Bulletin # SR-5K-002

SAFETY BULLETIN

Ride Name: Cliff Hanger

DARTRON IND., INC.		CLIFFHANGER CAR		REV. NO.	
1000 S. 10th St.		DARTRON		SR-5K-002	
DARTON, MISSOURI		2/2		0

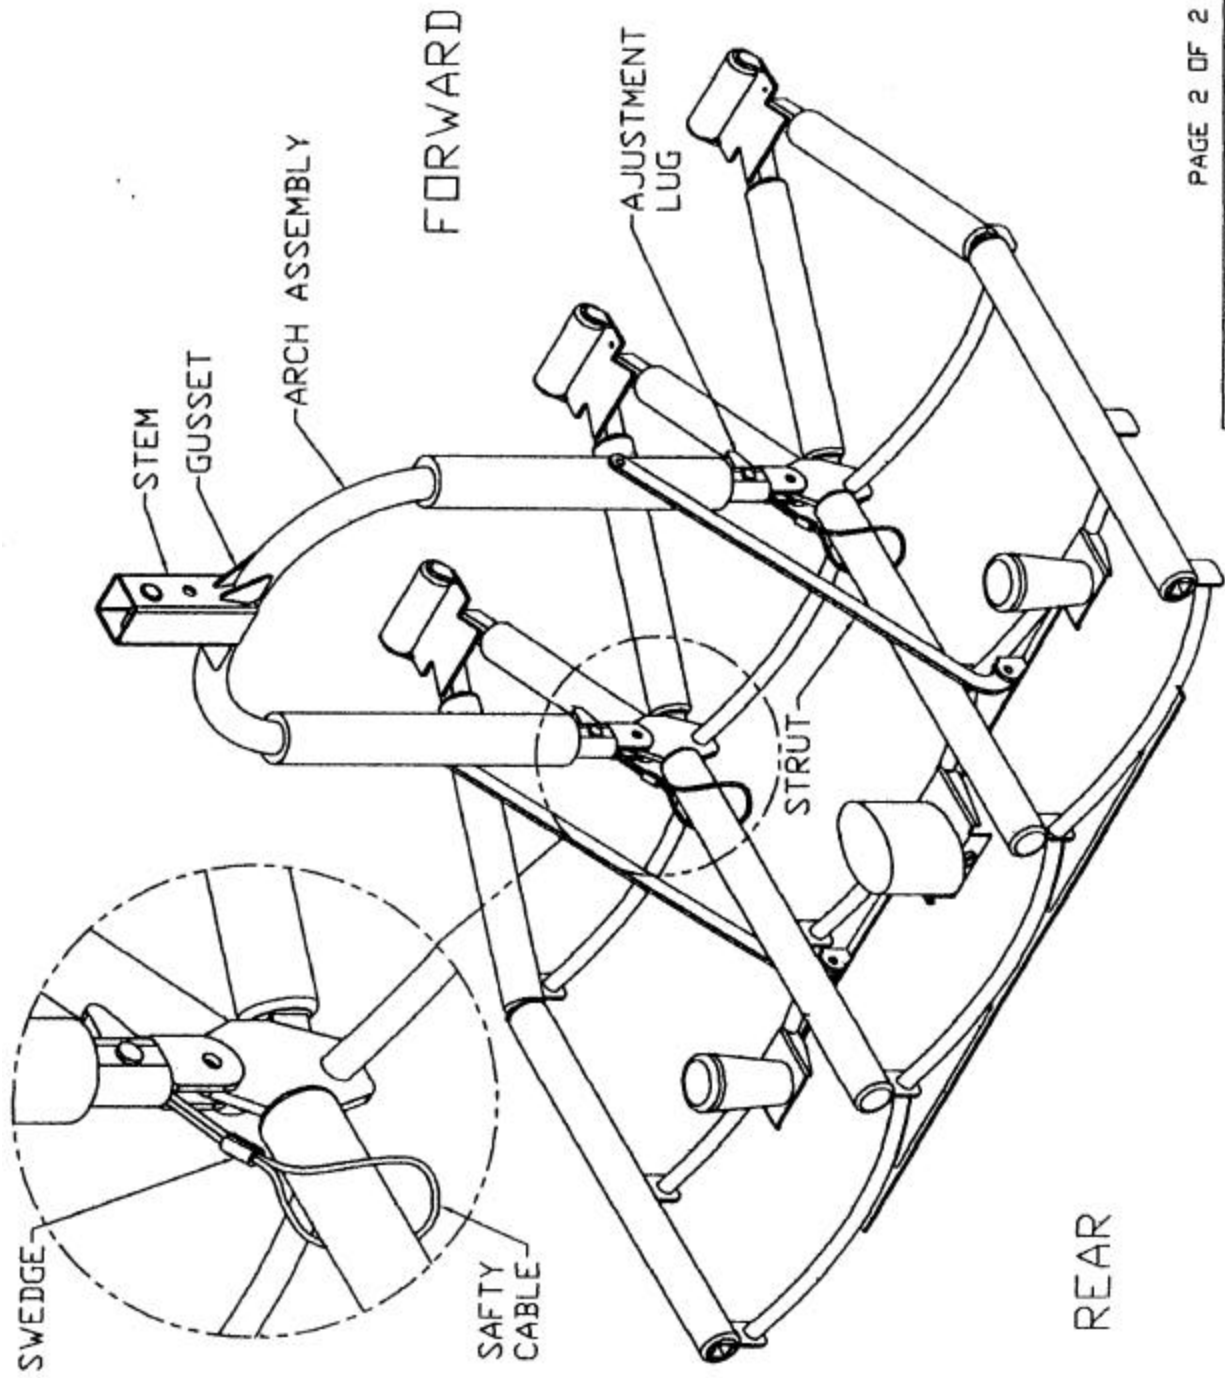
Abstract of Issue: An incident occurred on a Cliff Hanger ride operating in Florida. The cause of the incident is unknown at this time. The incident resulted from a failure in the Car Hanger Stem. The Car Hanger Stem is shown in Attachment I. As shown the Stem is connected to the Arch Assembly with four gussets that are welded to the Stem and the Arch Assembly. The failure occurred at the attachment point of the gussets to the Stem.

1. No Cliff Hanger is to be operated until the requirements of steps 2 through 6 are satisfied.
2. All welds and the heat effected areas adjacent to the welds on the gussets that attach the Stem to the Arch Assembly on each of the 10 car hanger Stems must be inspected by a certified Level II NDT Inspector using the Magnetic Particle Method. Contact Dartron at 800-421-5752 for NDT Inspection Forms. Using the Dartron supplied forms the NDT Inspector must submit a written report to Dartron documenting the result of the NDT inspection.

3. Dartron will determine from the NDT inspection report if the structural integrity of the gusset joint has been compromised.
4. If Dartron determines that the structural integrity of the joint has been compromised the defect must be remedied in a manner satisfactory to Dartron before the Car Hanger Stem can be used on the ride.

5. Each Car Hanger Stem must have a Dartron approved back-up system for the stem gusset joint. Dartron approved back-up systems include, a cable inserted inside the stem and attached to the passenger carrier or other Dartron designed and approved devices.

6. After Dartron has determined that the Cliff Hanger stem gusset joints have the desired structural integrity and a Dartron approved back-up the Cliff Hanger will be approved by Dartron as safe to operate and can be reopened subject to requirements of local jurisdictions and your insurance carrier.
